From: Wayne Craig
Director of Development

File: DP 13-630087

Re: Application by Zhao XD Architect Ltd. for a Development Permit at 8680 and
8700 Alexandra Road

2. **DP 13-630087 - FOUR (4) SINGLE-STOREY COMMERCIAL BUILDINGS**

DP 13-630087
A1.3
#3

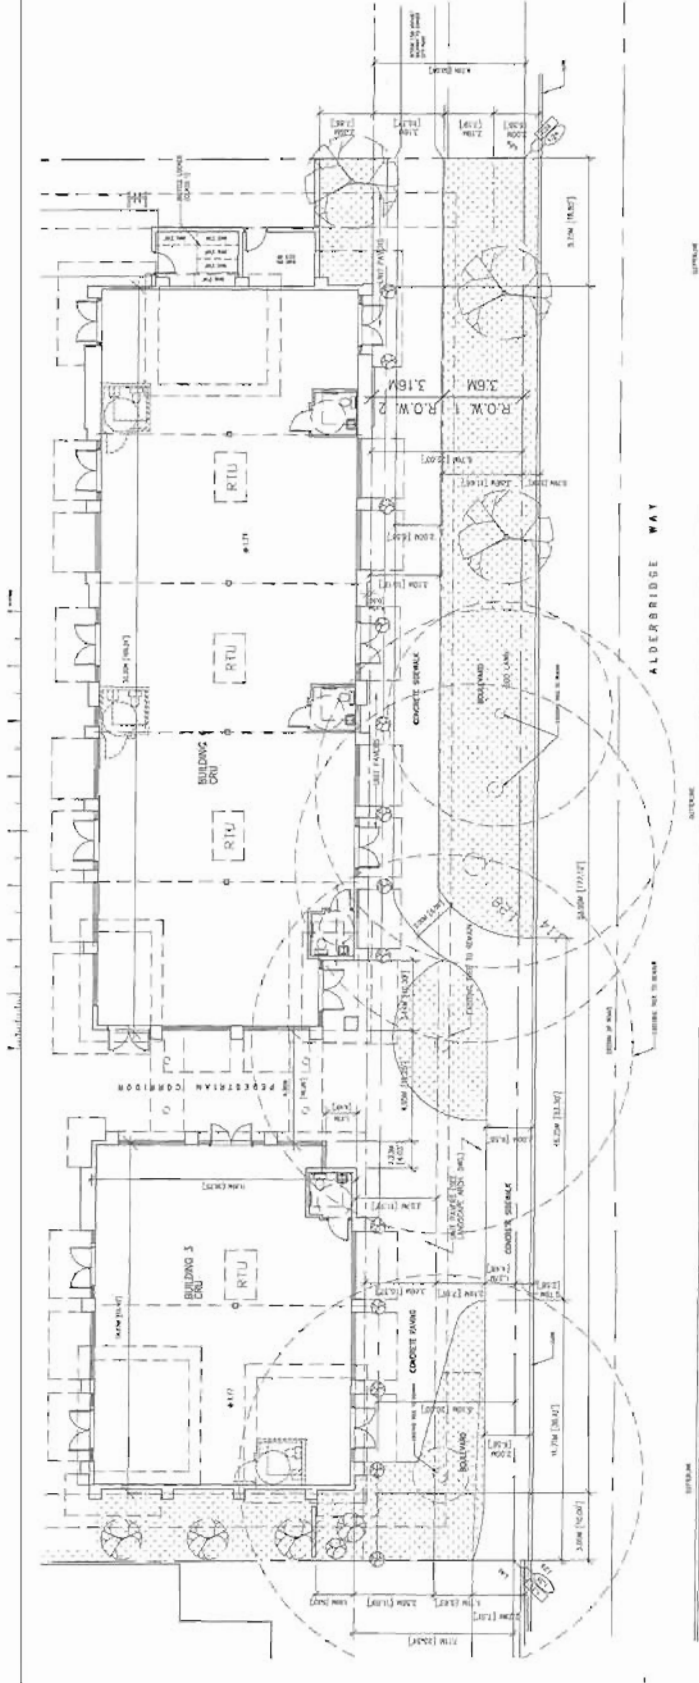
- Buildings 3 and 4 are in a challenging situation; commercial consideration necessitates that the buildings have two faces – front and back of the house; in the present situation, the primary face is facing within the development and on the other hand, the Alderbridge commercial frontage needs to be further animated and activated; the challenge facing the applicant is to find the right balance; at present, animation and transparency in the Alderbridge commercial frontage are not enough;

Corner cuts for both buildings have also been made to open up the southern access for the pedestrian corridor (drawing A1, A1.3, A4). Vision glasses are introduced onto the facade between Building 3 and 4 as suggested (drawing A5). The pedestrian corridor through the opening between Building 3 and 4 also supplements the transparency of the street frontage.

GARBAGE/RECYCLE ENCLOSURE DETAIL
 SCALE: 1/8"=1'-0"

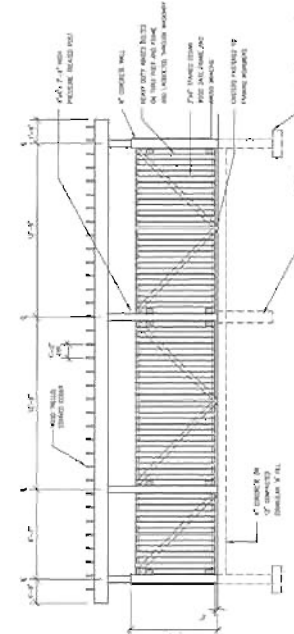
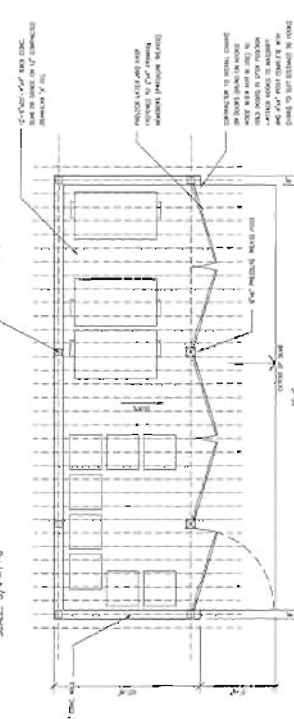
- good project; low in site coverage and density; gives a suburban feel; boxes are well articulated using different materials which create a village feel;
- appreciate the interesting areas of double height glazing at some key entrances of the buildings;
- garbage and recycling should be covered; more thought should be given to its design in view of the possible future location of restaurant in the development; garbage and recycling should also be secure and as far away as possible from the pedestrian corridor;

Concrete wall and metal siding are used for garbage/recycling enclosure so that the materials are referenced to buildings. The garbage/recycling enclosure is covered by trellis (drawing A5).
